**CITY OF MOUNDSVILLE
MARSHALL COUNTY, WEST VIRGINIA
FOUR SEASONS SPLASH PAD**

ADDENDUM #1

April 1, 2021

THRASHER PROJECT #030-10204

SIZE B	PROJECT # 16210	DWG NO 16210-2018-1WV-MOUNDSVILLE-MOUNDSVILLE LR & POOL-62	REV 1
DRAWN gwills		DATE 1/21/2021	SHEET 4 OF 11

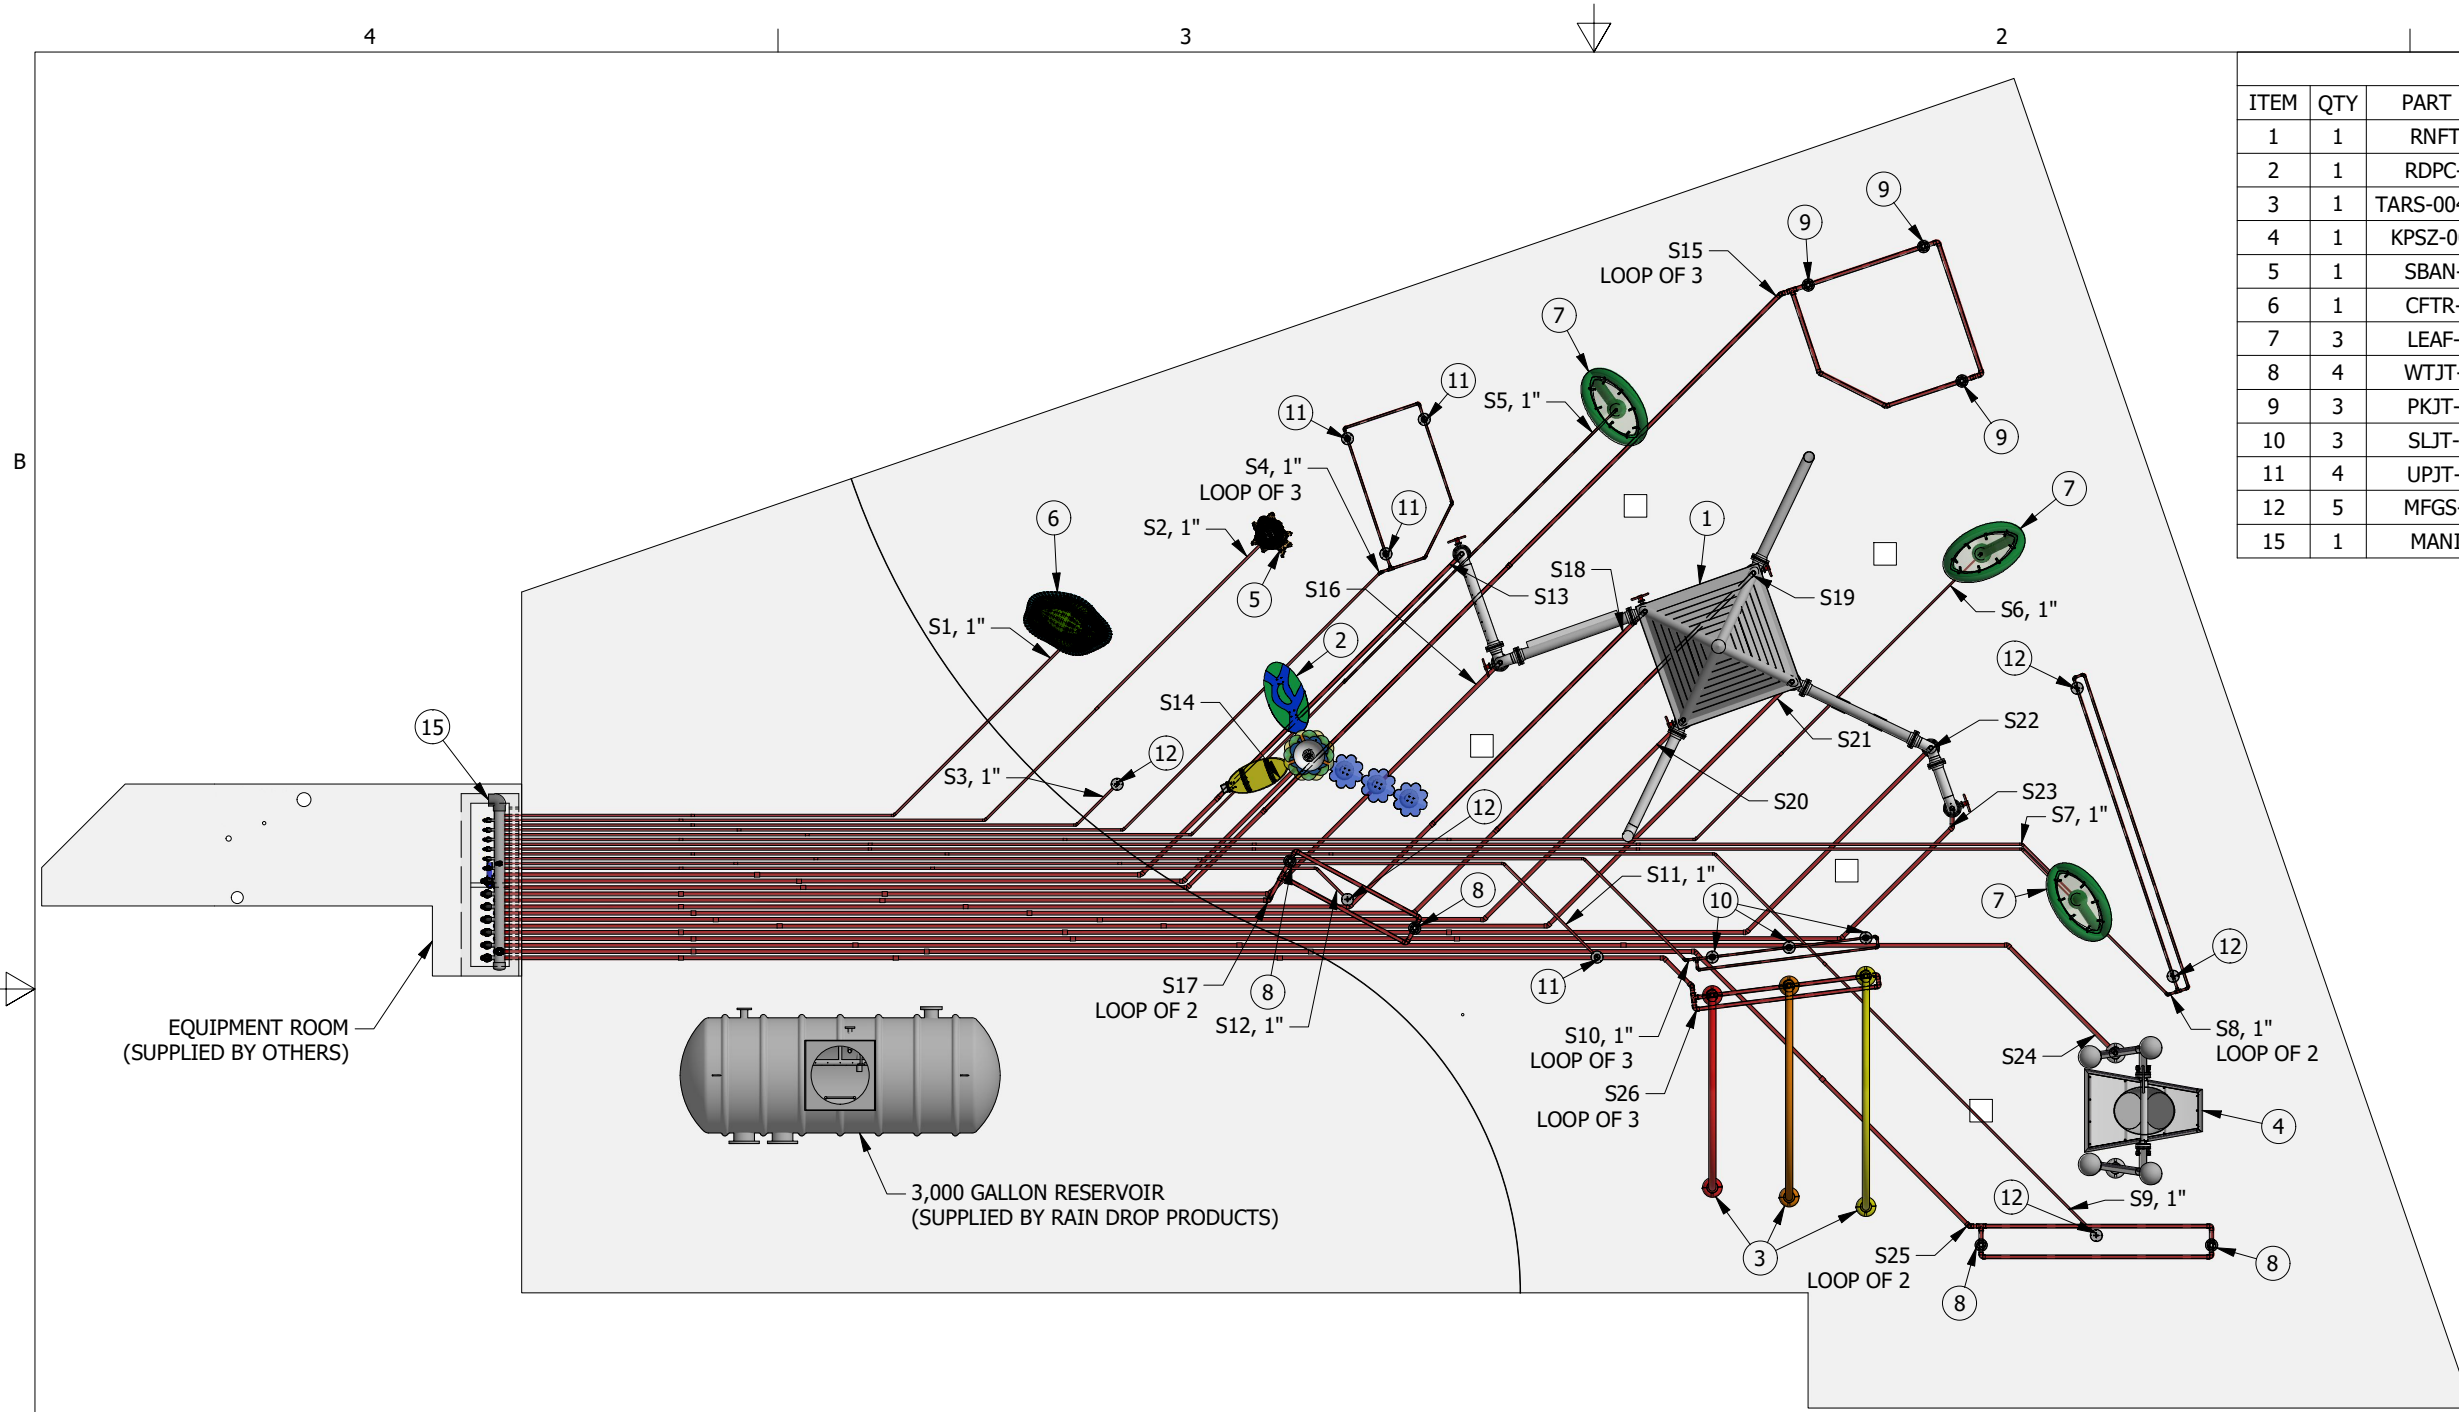
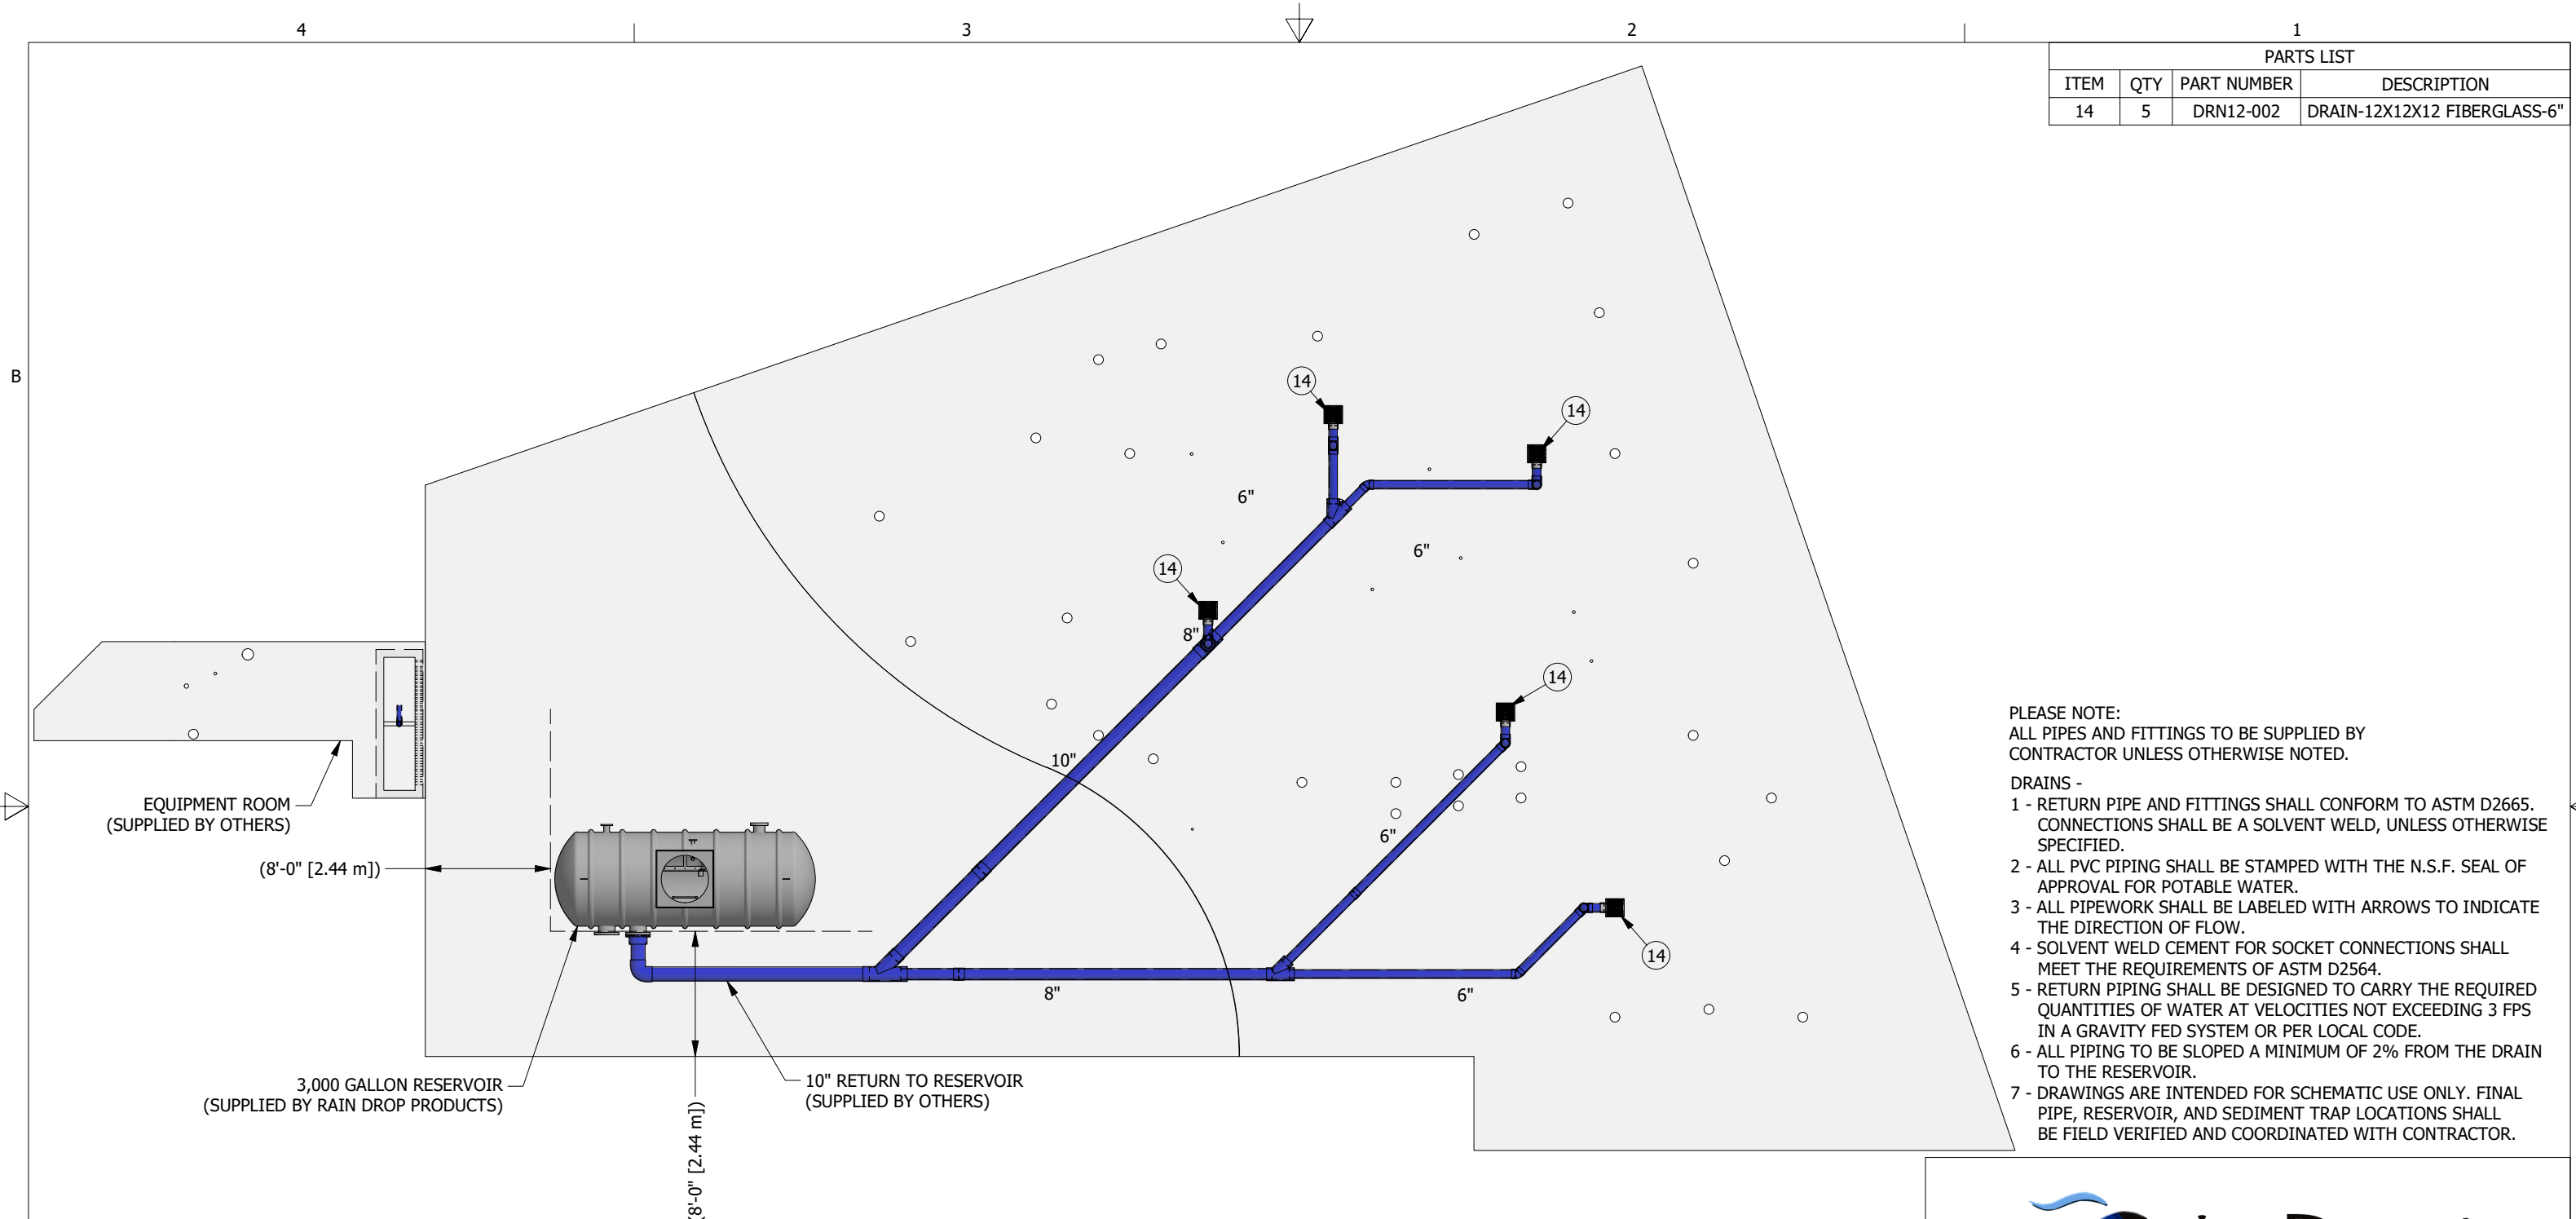
Is there a scaled Rain Drop drawing in order to arrive at the footages of piping required to connect from the manifold to their equipment? Same scenario for the drain piping and the area drains.

Sheets 4 of 11, 5 of 11, and 6 of 11 of the Rain Drop plan sheets are scaled at 1" = 10' when printed at 11x17 with no page scaling.
